269D™ HELICOPTER

ASB DB-072

SUBJECT: POWER TRAIN SYSTEM – Kaflex® Drive Shaft – One-Time Inspection for the Correct Bolt that Attaches the Drive Adapter to Kaflex® Assembly

KAFLEX® ASSEMBLY (SKCP2738-9) WITH BOLT (NAS565-39)
FIGURE 1

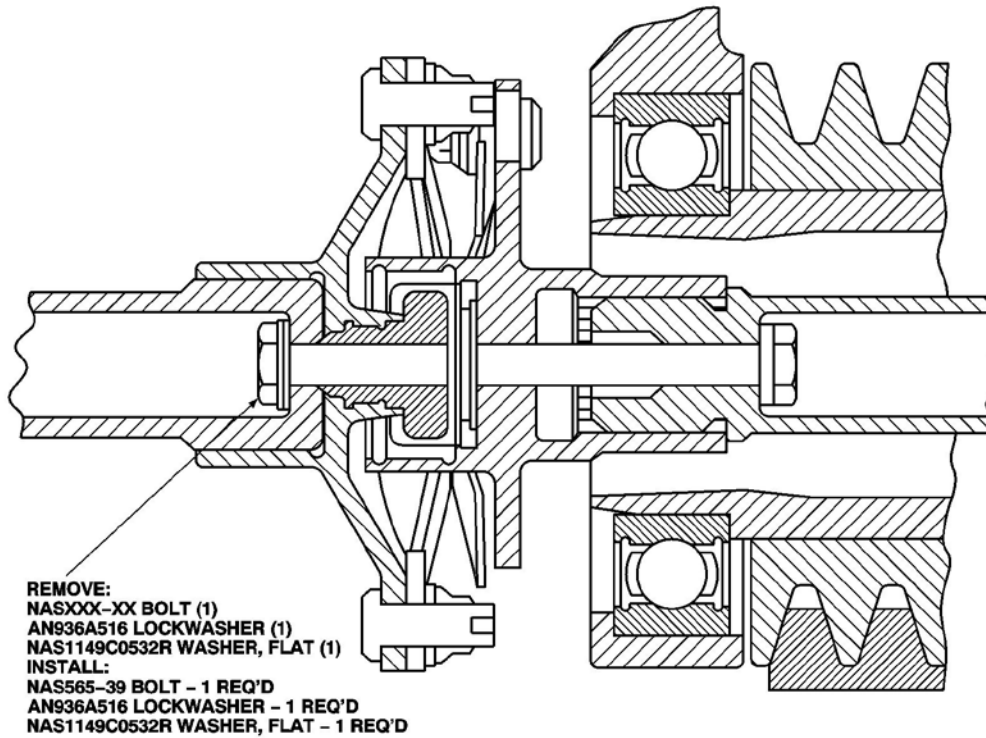
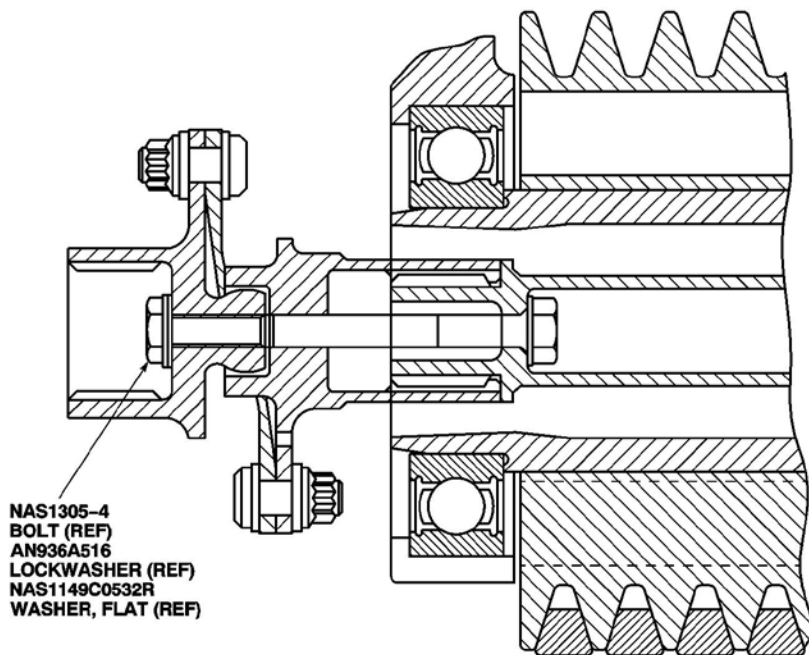
NOTE: Bolt securing drive adapter to KAflex® assembly varies in length depending upon what production KAflex® assembly is installed. For helicopters equipped with legacy KAflex® assembly (SKCP2738-7), bolt (NAS1305-4) is used. For helicopters equipped with new KAflex® assembly (SKCP2738-9), bolt (NAS565-39) is used.

B. Inspect drive adapter to KAflex® assembly attachment bolt as follows (Refer to Figures 1 and 2):

- (1) Remove bolt, lockwasher and washer from drive adapter.
- (2) Inspect bolt for part number "NAS565-39".
 - (a) If bolt part number is not "NAS565-39", discard bolt (NASXXX-XX) and replace with correct bolt (NAS565-39).
 - (b) If bolt part number is "NAS565-39" proceed to next step.

NOTE: Lockwasher (AN936A516) shall be installed between head of bolt (NAS565-39) and flat washer (NAS1149C0532R).

- (3) Install bolt (NAS565-39), new lockwasher (AN936A516) and flat washer (NAS1149C0532R).
- (4) Torque bolt to 100-140 in-lbs.
